Access Compliance Report

Public Rights-of-Way

Intersection ID: 31500	Main Street: CARLEEN_WAY_DR	Cross Street: GRIER_SPRINGS_LN	Location: S
ADA ID: CB00F95BF1B6	Ramp Type: BlendTrans1	Initial Pass/Fail: Fail	Overall Compliance: No
		Severity Score: 10

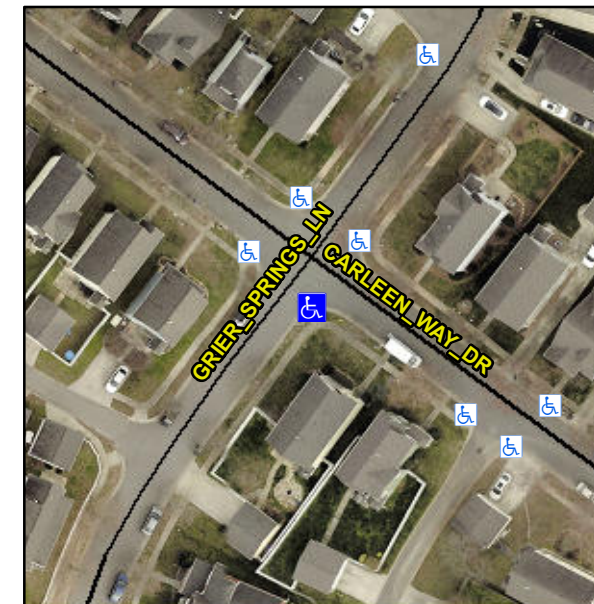
Not Found, R304.5.1, R304.5.3

Compliance	Description	Data	Compliance	Description	Data
N/A	Ramp Length (in)	60.0	Yes	BlendTrans Slope (%)	4.4
No	Ramp Width (in)	38.0	No	BlendTrans XSlope (%)	3.0
N/A	Flare Type LT	N/A	N/A	Flare Type RT	N/A
N/A	Flare Slope LT (%)	N/A	N/A	Flare Slope RT (%)	N/A
N/A	Flare Traversable LT?	N/A	N/A	Flare Traversable RT?	N/A
N/A	Landing Length (in)	N/A	N/A	DWS Provided?	N/A
N/A	Landing Width (in)	N/A	N/A	DWS Contrast?	N/A
N/A	Landing Slope (%)	N/A	N/A	DWS Length (in)	N/A
N/A	Landing X Slope (%)	N/A	N/A	DWS Full Width?	N/A
N/A	Landing Curb? (Y/N)	N/A	N/A	DWS Offset (in)	N/A
N/A	Shared Landing?	N/A			
N/A	Gutter Ponding?	N/A	N/A	Gutter Slope (%)	N/A
N/A	Gutter Lip Ht (in)	N/A	N/A	Gutter X Slope (%)	N/A
N/A	Painted X Walk1?	No	N/A	Painted X Walk2?	No
	X Walk 1 Direction	To NE		X Walk 2 Direction	To NW
	X Walk 1 Width (in)	N/A		X Walk 2 Width (in)	N/A
	X Walk 1 Slope (%)	7.3		X Walk 2 Slope (%)	0.6
	X Walk 1 X Slope (%)	1.9		X Walk 2 X Slope (%)	3.0

N/A	Ramp inside XWalk1?	N/A	N/A	Ramp inside XWalk2?	N/A
	Road Slope (%)	2.3		Clear Space?	N/A
	Road X Slope (%)	6.2	N/A	Clear Space to XWalk (in)	N/A
N/A	Any Obstructions?	N/A	N/A	Storm Grate/Utility Hazard?	N/A
	Obstruction Type			Storm Grate/Utility Type	
		N/A			N/A
			Yes	Surface Condition? (G/P)	Good
			No	Curb Slope (%)	20.0

Remove & Replace Curb Ramp With Two New Directional Ramps or Equivalent.
